ADDENDUM NO. 2
TO PLANS, SPECIFICATIONS AND CONTRACT DOCUMENTS

FOR: RALSTON PUBLIC SCHOOLS
SEYMOUR ELEMENTARY SCHOOL
PARKING LOT IMPROVEMENTS
LRA JOB NO. 0109114.01-021/321

DATE: MAY 12, 2010

Sheet 5 of 8 - Revised Typical Handicap Striping Sign Detail

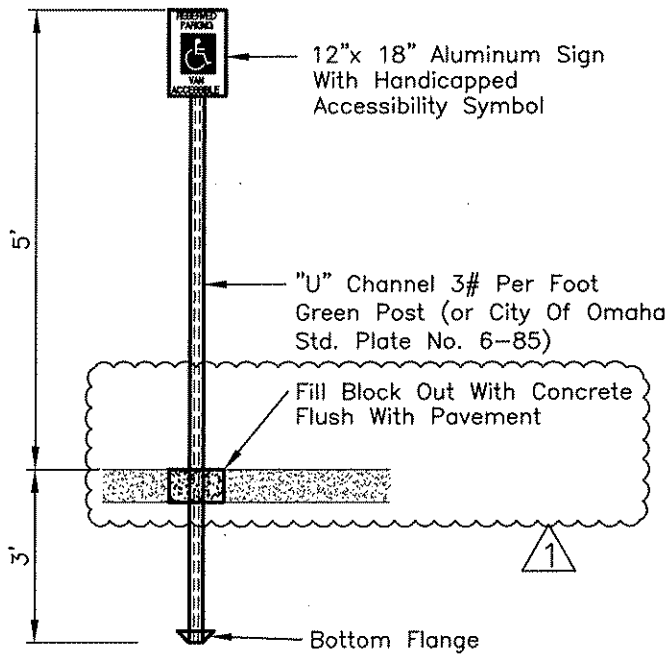
1. Sheet 1 of 8 – Add Bid Item No. 55 “PERMANENT PAINTED CROSSWALK STRIPING” and Bid Item No. 56 “CONSTRUCT ONE-WAY SIGN”.
2. Sheet 4 of 8 – Modify paving keynote P7 to include “ 9” Block Out For Salvaged Handicap Sign”.
3. Sheet 4 of 8 – Modify paving keynote P19 to include “ 9” Block Out” for salvaged designated parking sign.
4. Sheet 4 of 8 – Added dimensions for crosswalk striping.
5. Sheet 5 of 8 – Revised TYPICAL HANDICAP STRIPING SIGN DETAIL to include block out in pavement for sign post installation.

SIGN DETAIL

TYPICAL HANDICAP STRIPING DETAILS
